CITY OF ST. PETERSBURG, FLORIDA
PLANNING & ECONOMIC DEVELOPMENT
DEPARTMENT, URBAN PLANNING & HISTORIC
PRESERVATION DIVISION

STAFF REPORT

COMMUNITY PLANNING AND PRESERVATION COMMISSION CERTIFICATE OF APPROPRIATENESS (COA) REQUEST

| Request: | Approval of: 1) Certificate of Appropriateness for the construction of a Rooftop Spa Deck and Lounge; 2) Variances for: a) building setbacks along streets (east, west, south elevations, including the 60 degree triangle from Beach Drive; b) distance between buildings (north elevation) |

Elevation views of proposed rooftop addition; also see Appendices E and G for 11" x 17" versions.
Plan drawing submitted by Architect for Applicant, 2016.

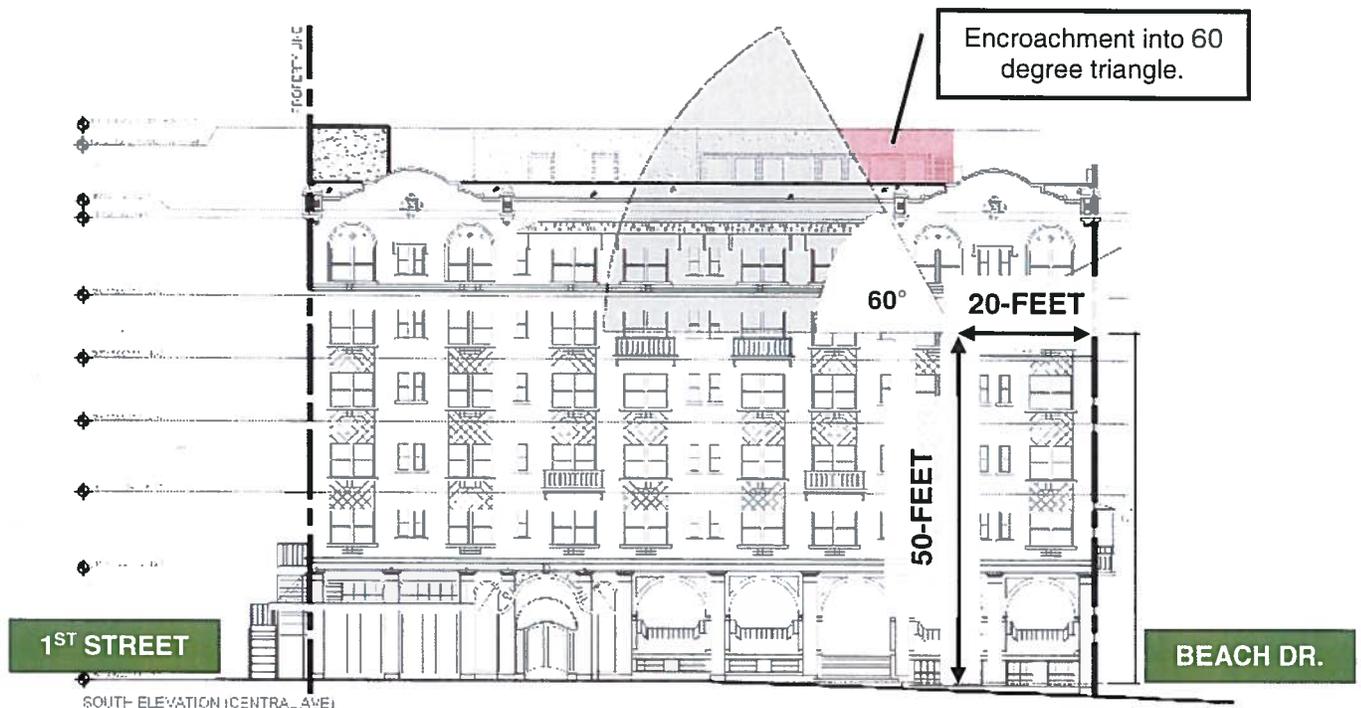
One item of concern is that even though the new structures are considered to be one story, the intended 12-foot height at certain wall planes without meaningful articulation appears to overwhelm the roof area. This may be caused in part by the requirement to raise the existing structure, which in turn, increases the height appearance of the new structures above the historic parapet. Lowering the height of the primary rooftop addition may provide better compatibility; however, this type of proportional relationship was not essential to a previous and similar approval, which not only added an additional non-historic floor, but also established an approved rooftop height for accessory structures at approximately 23 feet, and a mechanical structural element at 16 feet in height. This previous approval for an unrelated property in 2011 appears to have been softened through articulated wall plane surface materials, which would also benefit the proposed undertaking (Condition 1).

The west and north elevations do not carry any proposed windows, which would be appropriate for the comfort station space at the west extent. It is acknowledged that additional design articulation would benefit the structure approaching its west extent to avoid blank, lifeless wall planes (Conditions 1, 4).

4. Minor tile inlays, in reference to the historic elevation detailing shall be added along the exposed elevations of the proposed primary rooftop structure elevations as approved by Staff.

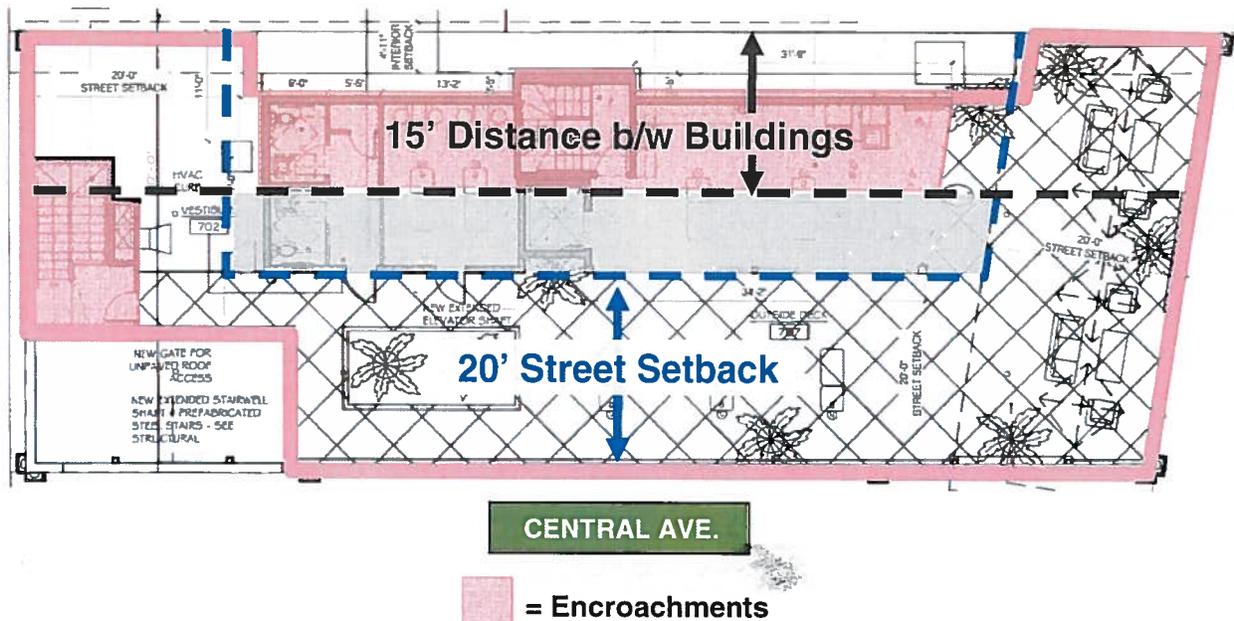
The 60 degree triangle is required for portions of the building above 50 feet that are located along Beach Drive Northeast. The seventh floor building addition encroaches into the required 60 degree triangle. The existing fifth and sixth floors already encroach into the required 60 degree triangle. The encroachment is for only a portion of the new addition. The volume of the proposed encroachment is approximately 3,903 cubic feet. A diagram illustrating this encroachment is attached to the report. The 60 degree triangle setback in the Code is to prevent large building towers from being built right up to Beach Drive. This is to maintain the feeling of openness along Beach Drive and the waterfront park system.

The proposed seventh floor addition will be set back 20 feet from the front plane of the existing building along Beach Drive. Having the additional setback of 20 feet will minimize the encroachment from street level and will give the perception that there is not an encroachment into the required 60 degree triangle. The encroachment is to allow for one additional floor to be built.

1
A-1.1
NEW ROOF PLAN
SCALE: 1/8" = 1'-0"

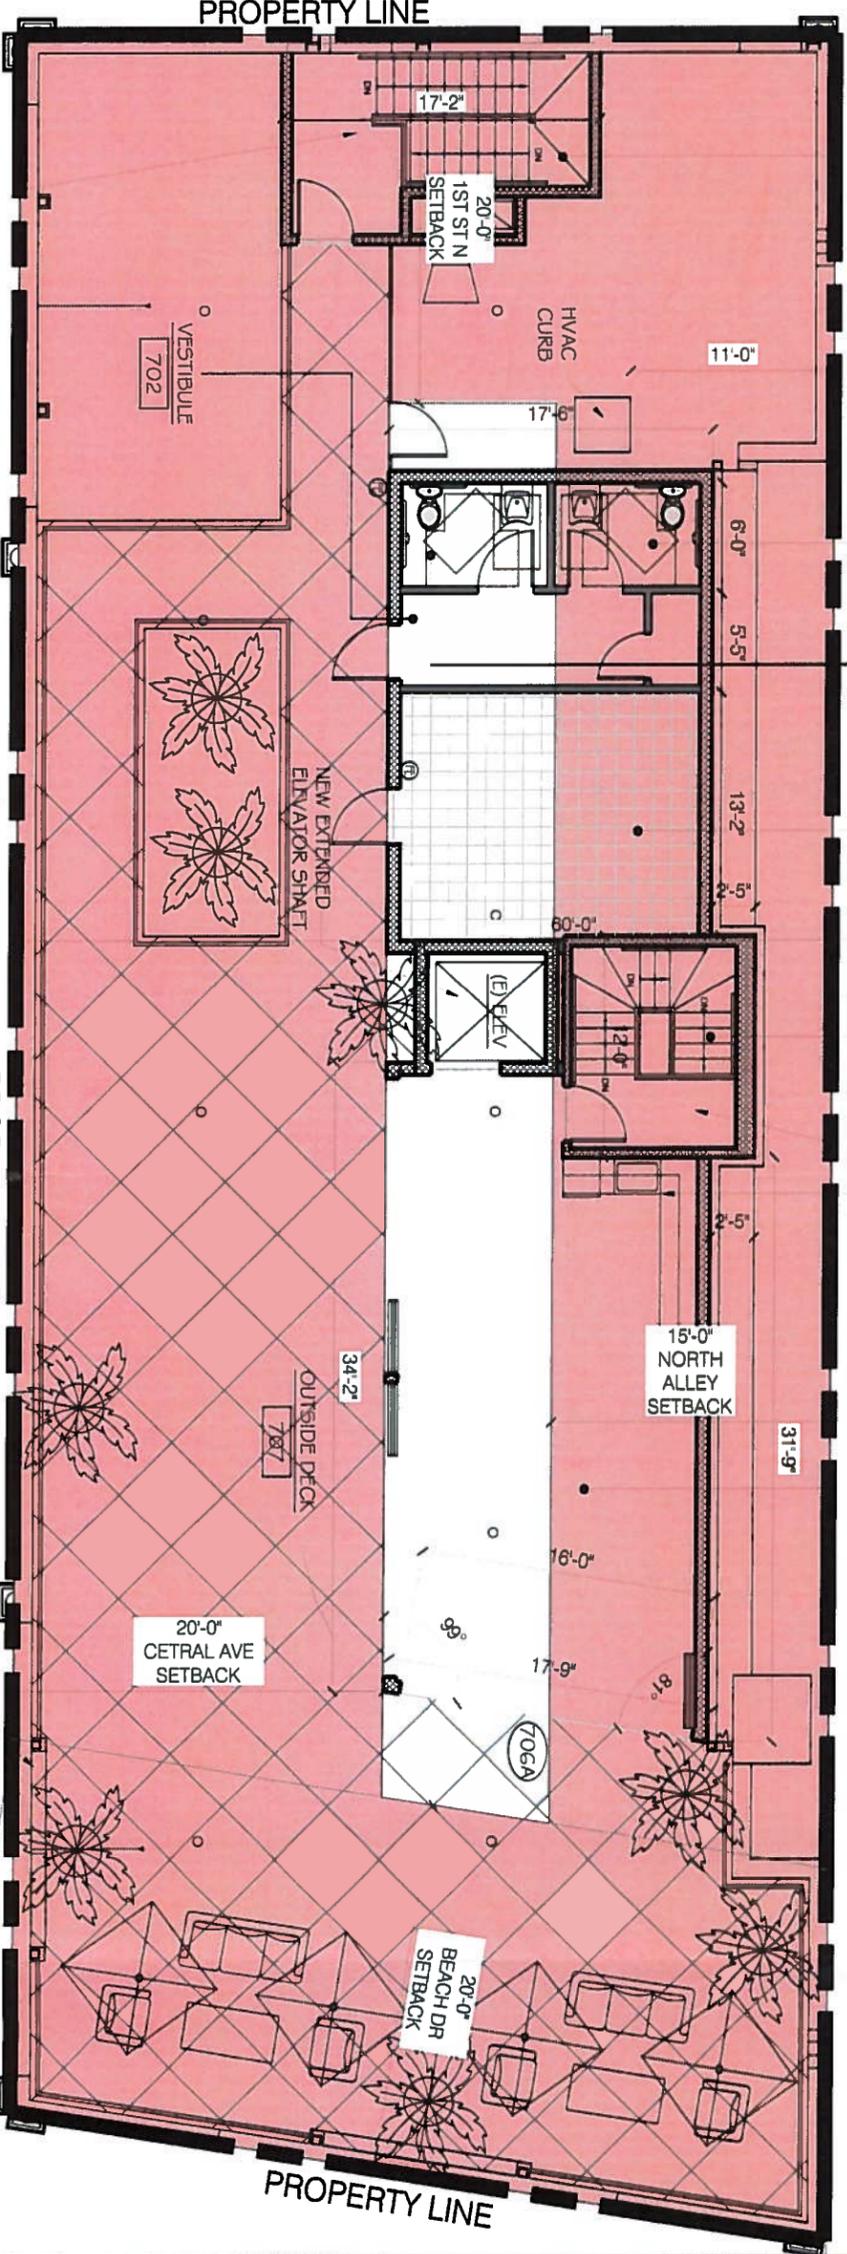
NEW GLASS RAILING EXTENSION AT
EXISTING PARAPET TO PROVIDE 42'
HIGH MINIMUM GUARDRAIL - TYP.
WHERE SHOWN (NOTE 48" HIGH
SHOWN ON ELEVATIONS TO MATCH
(E) DECORATIVE PARAPETS)
